**RESPONSE TO ENVIRONMENTAL PROTECTION
AGENCY'S DRAFT NPDES PERMIT**

**PSNH MERRIMACK STATION
UNITS 1 & 2
BOW, NEW HAMPSHIRE**

**Prepared for
Public Service Company of New Hampshire**

**Enercon Services, Inc.
500 TownPark Lane, Suite 275
Kennesaw, GA 30144**

Figure 1: Spacing Criteria for Johnson CWW Screens [Ref. 6.19]

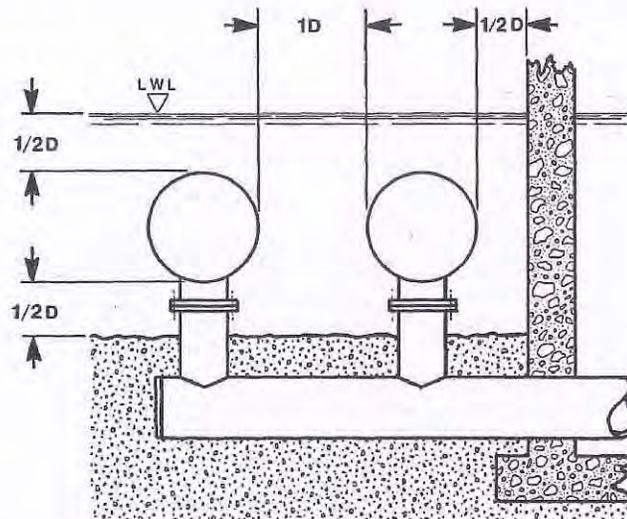
In the draft permit, EPA also concludes that the Merrimack River is too shallow for CWW screens. The 2009 Report [Ref. 6.2] indicated that a CWW screen diameter of 24 inches was chosen for the design of Merrimack Station to take into account the mean low water level of 4 ft. Correspondence with Johnson Screens, the leading CWW screen manufacturer, indicates that one half diameter of clearance must be provided above and below the outer edge of the screen [Ref. 6.2]. The Product Application Guide from Johnson Screens [Ref. 6.19] also gives this spacing requirement, shown in Figure 1. For a 24-inch diameter screen, this signifies a requirement of one foot of water above the top of the screen, and one foot of water between the bottom of the screen and the bottom of the river. Therefore, 24-inch diameter CWW screens can be designed to operate in as little as 4 ft of water.

The 2009 Report presented a preliminary layout of CWW screens. This preliminary layout showed CWW screens being installed from approximately 60 ft to approximately 95 ft offshore in front of the existing Unit 1 and 2 screen houses [Ref. 6.2]. As discussed in the 2009 Report, the mean low water level in the vicinity of the CWW screens is 4 to 6 ft, with an average depth of 6 to 10 ft. Crude bathymetry data provided by Normandeau for the lower Hooksett Pool demonstrated water depths of approximately 7-15 ft along this transect in the region closest to where the CWW screens would be installed (Attachment 1, Section 2). This data is obtained from the N-5 transect, located just south of the intake structure [Ref. 6.11]. More detailed bathymetry data would be necessary to confirm the depths of the river in this area, but currently available data suggests that water depth would not be an issue for a 24-inch diameter CWW screen installation.

Figure 3: Existing Open-Cycle Cooling Flows at Merrimack Station

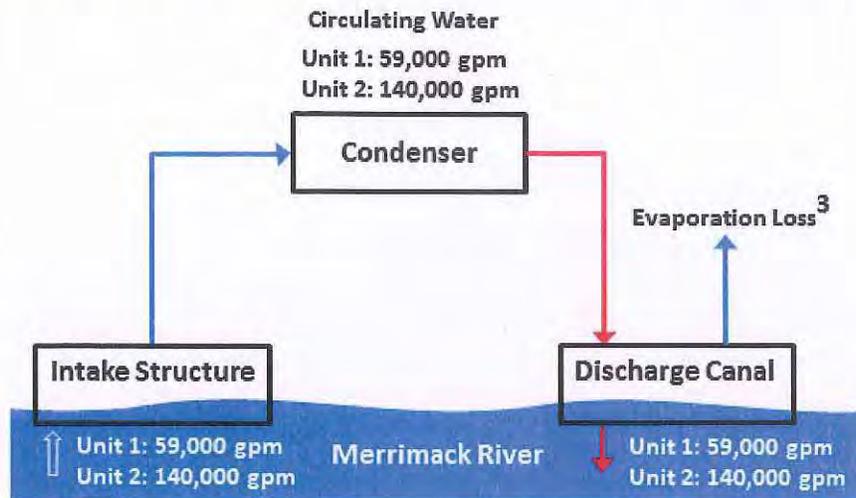
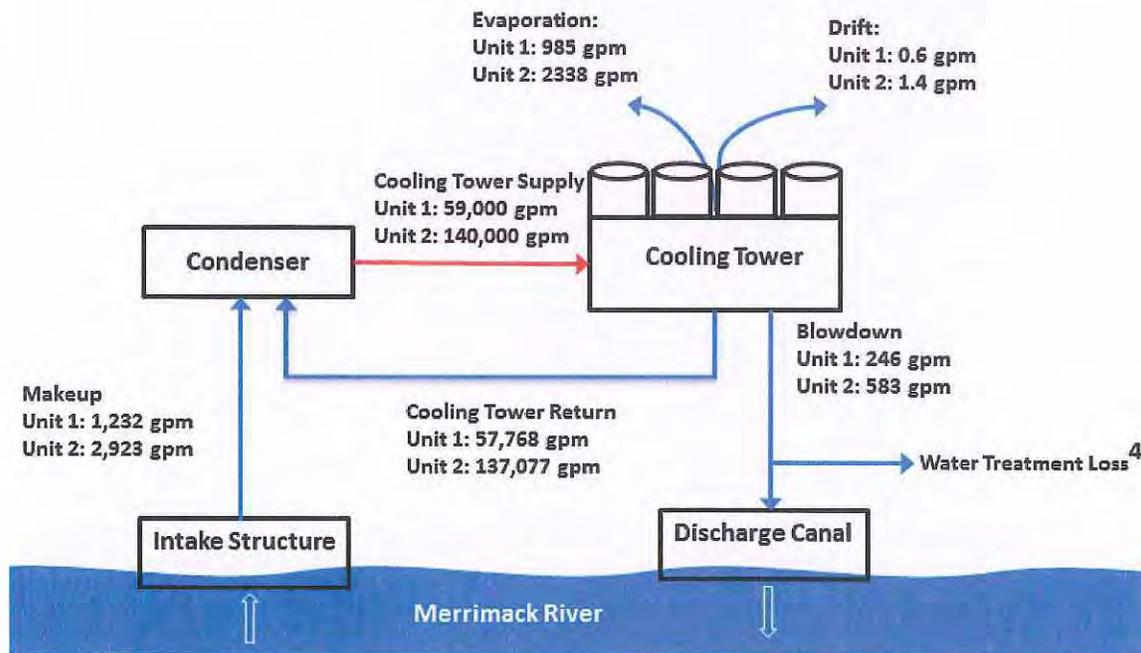
In the draft permit, EPA states that the PSNH estimation of the impact of additional evaporation upon the Merrimack River errs on the high side because it does not take into account evaporation already occurring in the existing cooling system. Although this statement is technically correct (the evaporation resulting from operation of the current system was not included in the estimation), the current cooling system evaporates only a very small amount of water, especially when compared to the evaporation that would occur using a wet or hybrid cooling tower. Unlike cooling towers, the primary mechanism by which the PSMs cool water is convection, and not evaporation. Additionally, the existing

The 2007 Response indicated that evaporation loss from the Hooksett Pool due to a cooling tower was a concern. It was estimated that the total loss of river water due to installation of a cooling tower would be 4.79 million gallons per day. This represents a significant loss of water from the Hooksett Pool daily. While small compared to evaporation losses, the water loss from cooling tower drift could still represent measurable water losses over time. According to SPX Cooling Technologies (SPX) "Cooling Tower Fundamentals" [Ref. 6.8], drift rate can be estimated by multiplying the total water flow rate by 0.02%. Given a total combined flow rate of 199,000 gpm for Units 1 and 2, this represents over 57,000 gallons per day of additional water lost from the Hooksett pool. Using state-of-the-art drift eliminators, the drift rate of the cooling tower could potentially be restricted to 0.001% of the total water flow rate, reducing the amount of water lost to drift daily to 2,880 gallons per day, as conservatively estimated in the 2007 Response [Ref. 6.3].

Simplified schematics of the closed-loop and open-loop cooling water system configurations are shown in the Figures below; Figure 3 depicts the existing open-cycle configuration, while Figure 4 shows a potential closed-cycle configuration. It is estimated that the closed-cycle cooling system would consume approximately 3,325 gpm of water. This amount of water loss is equivalent to approximately 2,640 Olympic-sized swimming pools per year [Ref. 6.21]. Note that several smaller miscellaneous loads (e.g., slag sluice, de-icing recirculation, travelling screen wash, equipment cooling, fire water, etc.) are not included in the schematic diagrams below for simplicity.

It is important to note that while a closed-cycle cooling system draws significantly less water from the river than an open-cycle cooling system, it consumes significantly more
